STAFF REPORT: 7/09/2025 REGULAR MEETING

APPLICATION NUMBER: HDC2025-00260

ADDRESS: 14943 GREENVIEW

SCOPE: DEMOLISH GARAGE, ERECT NEW GARAGE (WORK STARTED WITHOUT APPROVAL)

Elevation drawings, submitted by applicant

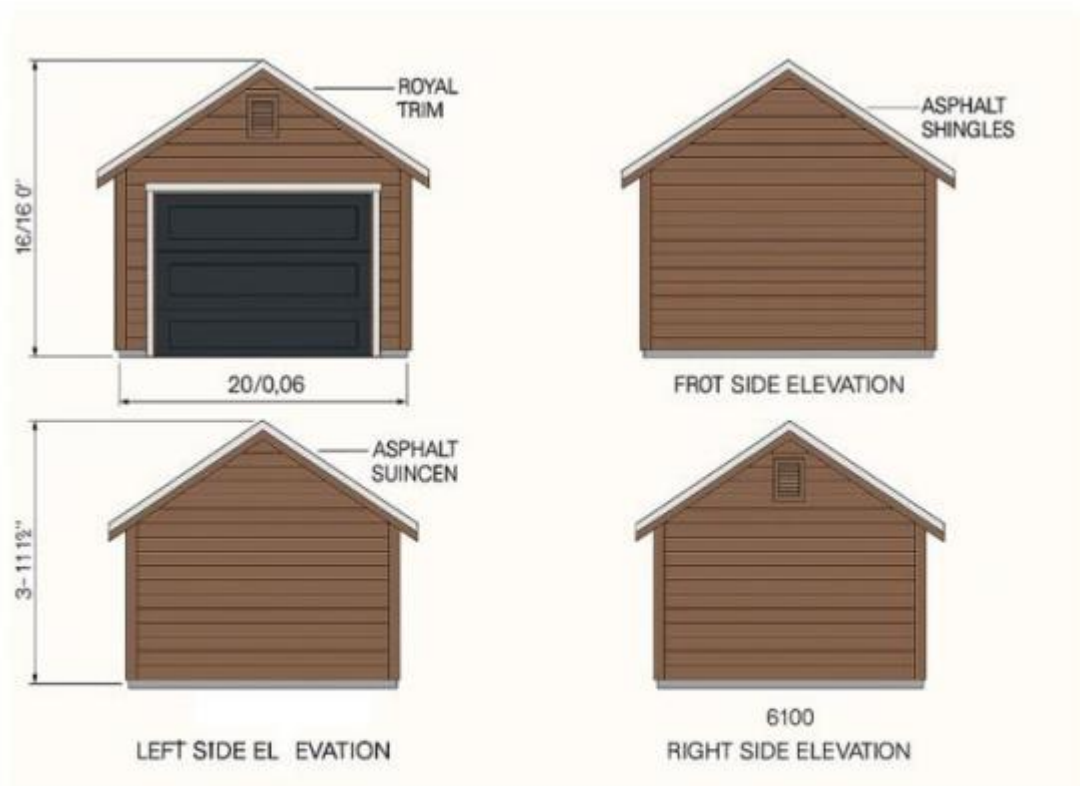
- While the application is generally complete, staff did note a small number of missing/incorrect details including:
 - Submitted drawings incorrectly depict the non-gabled (north and south) sides
 - The paint color for the walls and the color of the asphalt roofing has not been indicated
 - The soffit and fascia material has not been indicated
 - Complete dimensions of the garage have not been indicated/confirmed. (Applicant describes the "width" as 16'.)
 - The foundation material has not been indicated

- **How will the non-gabled (north and south) sides look?** If the project proposes a simple and modest building and 13' remains the maximum height at peak, staff would say that the design meets both the Standards for Rehabilitation and the Elements of Design.

- Staff believes that the use of vinyl trim is not compatible with the Standards or the Elements of Design because it is not compatible with the appearance of the historic materials on this property or in the nearby neighborhood. Wood or a cementitious material (with a smooth finish) would present a more appropriate appearance, in staff's opinion.

- **What color will the wood siding be painted?** Whatever color the applicant has selected, it must relate to the historic house, as brown did before the fire.

- **Which color will the asphalt roof be?** Again, it will need to relate to the historic house to adhere to the Elements of Design.
 - **What is the material for the soffits? Fascia boards? Will they be covered with another material?** Painted wood (and/or possibly aluminum) would be the most appropriate material to use for this purpose because wood is a common material in the district and it would be compatible with the historic materials on this house and nearby buildings.

- **Garage size and scale:** It is understood from the application and materials that the garage will be 16' wide; **the length is needed.** As long as the footprint and height of the proposed new garage are close to those of the old garage (14' x 20'), the Standards for Rehabilitation and the Elements of Design will both be satisfied because a modest scale and size for a garage is compatible with the historic house and the neighborhood.

- **What is the garage's foundation?** The materials used on the foundation, if they will be visible above ground, need to be compatible with historic materials on the historic house and in the neighborhood in order to comply with both the Standards and the Elements of Design.

- The applicant shall submit final dimensioned drawings of the garage which outline paint color(s) and materials to staff for review and approval prior to the issuance of the permit

- Vinyl shall not be used on the new construction and all trim shall be made of wood or a cementitious material (with a smooth finish)
- The garage's walls, asphalt roofing, soffits, fascia, and exterior doors shall be finished with colors that are compatible with those found at the property's historic house.
